Staff Summary Report

SUBJECT: Hold a public hearing for a Use Permit and Development Plan Review for CHRIST LIFE CHURCH located at 1137 East Warner Road.

COMMENTS: Request for **CHRIST LIFE CHURCH (PL070397)** consists of the addition of the 34,378 s.f. Jim Roam Family Center to the existing church facility on +/- 4.49 net acres in the AG Agricultural District. The request includes the following:

CHRIST LIFE CHURCH - EXPANSION (PL070397)

1 SITE PLAN
1" = 20'-0"

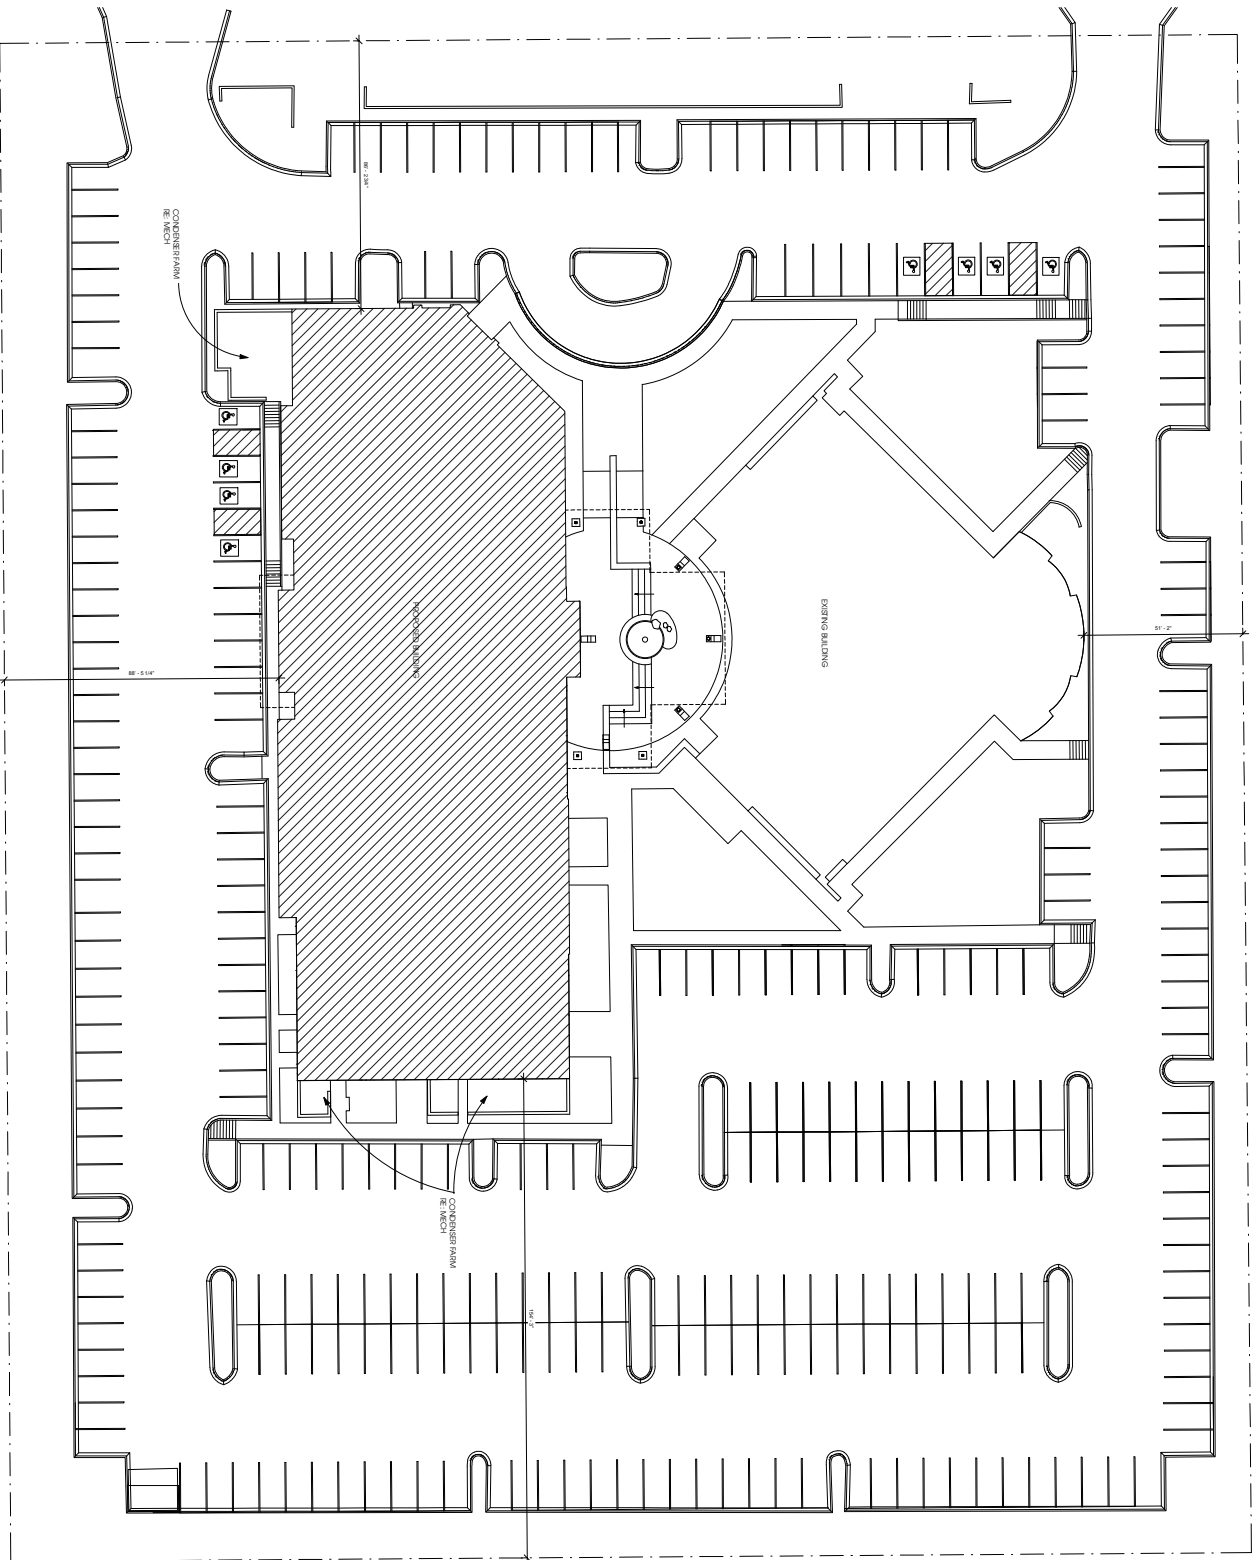
- Correctly indicate the following existing features on the site plan:
 - The walkway that connects the on-site walkway network to the public right of way.

- The site monument sign and the parking screen walls facing Warner Road.
 - The meandering public sidewalk and the curb, gutter and driveways in the adjacent off-site frontage.

- The row of four existing parking spaces and landscape islands in the parking row immediately southeast of the Worship Hall.
- Add missing items to the site plan as follows:

- Add a landscape island immediately east of the refuse enclosure.
 - Add a landscape island at the north and a landscape island at the south end of the parking row immediately west of the Family Center.

- Add an intermediate landscape island at the former refuse enclosure location in the parking row along the west property line. Provide a total of three intermediate islands in this westernmost parking row, rather than the two that are indicated on the site plan.

- Add bicycle parking required by the parking calculation. Provide 2'x6' spaces with bike rack in conformance with Standard Detail T-578. One rack may serve two adjacent bike parking spaces. Locate bike spaces in high visual surveillance areas near building entrances.

- Provide walkways connecting exit doors through adjacent planting areas to the site walkway network.
- On the site plan, layout fire lane around perimeter site drive aisle. Maintain a 20'-0" drivable fire lane width with 45'-0" turn outside radius and 14'-0" vertical clearance from fire lane surface to underside of trees.

- Verify with Public Works / Solid Waste Department (480-350-8127 or joseph_kolesar@tempe.gov) that the Standard Detail DS-116 refuse enclosure proposed at the southwest site corner may be a single enclosure as indicated or must be a double enclosure due to the increased building area.
